WELL API NO.
30-015-22647
5. Indicate Type of Lease
STATE [] FEE [x]
6. State Oil & Gas Lease No.
7. Lease Name or Unit Agreement Name
Pardue Farms '26'
8. Well Number
2
9. OGRID Number
241333
10. Pool name or Wildcat
S. Culebra Bluff Bone Spring
11. Elevation (Show whether DR, RKB, RT, GR, etc.)
3,022.5' GL

SUNDRY NOTICES AND REPORTS ON WELLS
(DO NOT USE THIS FORM FOR PROPOSALS TO DRILL OR TO DEEPEN OR PLUG BACK TO A
DIFFERENT RESERVOIR. USE "APPLICATION FOR PERMIT" (FORM C-101) FOR SUCH
PROPOSALS.)
1. Type of Well: Oil Well [x] Gas Well [] Other []
2. Name of Operator
Chevron Midcontinent, L.P.
3. Address of Operator
6301 Deauville Blvd Midland, Texas 79706
4. Well Location
Unit Letter D : 760 feet from the North line and 990 feet from the West line
Section 26 Township 23-S Range 28-E NMPM County Eddy
11. Elevation (Show whether DR, RKB, RT, GR, etc.)
3,022.5' GL

Action 257326

CURRENT WELLBORE DIAGRAM

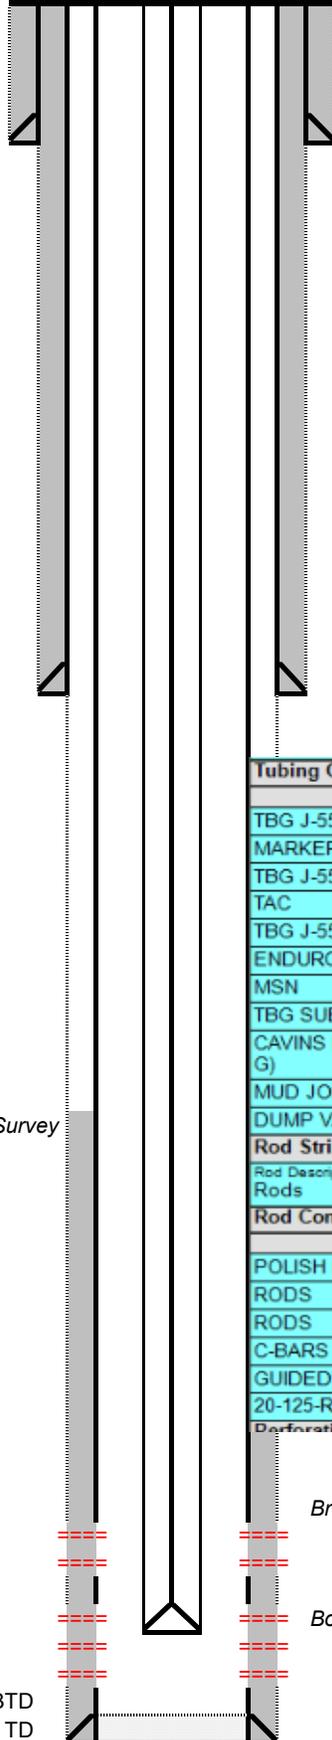
Run CBL

SEE CHANGES TO PROCEDURE

SEE ATTACHED COA's

MUST BE PLUGGED BY 6/1/24

- 1 MIRU, pull rods and tubing. A. Set CIBP @6350' w 25 sx cmt - WOC & tag - T BS
- 2 Set CIBP within 100' of top perf at 5,916'
- 3 Spot 25 sx Class C f/ 5,916' - 5,556' (WOC/tag, pressure test barrier)
- 4 Spot 25 sx Class C f/ 4,725' - 4,365' (Brushy Canyon)
- 5 Perf & Squeeze 50 sx Class C f/ 3,463' - 3,258' (Cherry Canyon)
Pressure test barrier
- 6 Perf & Squeeze 150 sx Class C f/ 2,647' - 2,027' (Bell Canyon, Base of Salt, 8-5/8" shoe)
Pressure test barrier
- 7 Cut and pull 4-1/2" production casing from 1,500'
- 8 Spot 58 sx Class C f/ 1,550' - 1,300'
WOC, tag, pressure test barrier - min. plug length 50' above and below casing stub
- 9 Bubble test 8-5/8" and all annuli. Notify NMOCD of any fails and address as needed.
- 10 Spot 136 sx Class C f/ 500' - 0'
Confirm cement to surface in all annuli
- 11 RDMO
